# Report to Development Permit Panel

| **Re:** | **Application by Citimark-Western Wembley Project Ltd. for a Development Permit at 4991 No. 5 Road** | | |

# DP 15-709934
# SCHEDULE "A"

**BUILDING 19**
**NORTH ELEVATION**

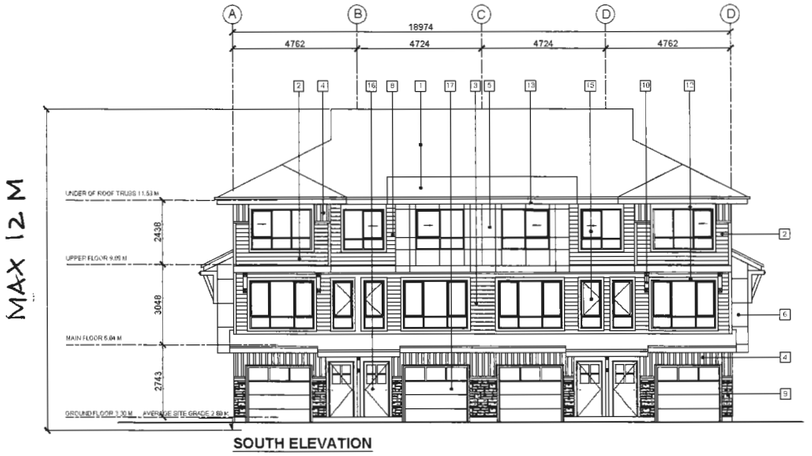
- Building 19 is a tall building and its windows are overlooking the neighbours; consider introducing appropriate landscaping to address overlook issues; – ***Taller trees were added to enhance screening. Building 19 has 4 units that are oriented with north and south views and a greater 6 m setback from the shared north property line. The number of units with north facing views was reduced to 4 units from the 8 units proposed through the previous rezoning application scheme.***
